MWO 9-2320-279-20-9

MODIFICATION WORK ORDER

MODIFICATION OF M977 SERIES 8X8 HEAVY EXPANDED MOBILITY TACTICAL TRUCK (HEMTT)

INSTALLATION INSTRUCTIONS FOR BOLT TOGETHER WHEELS

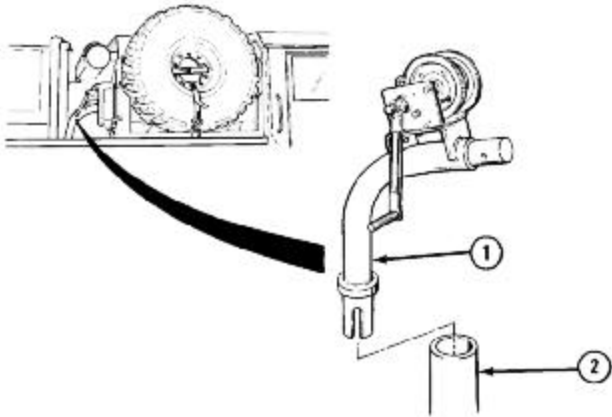
- a. Prepare Tire and Davit:
 - (1) Completely deflate spare tire, cut the valve stem and discard.

(2) Remove hoist arm (1) from mounting bracket (2).
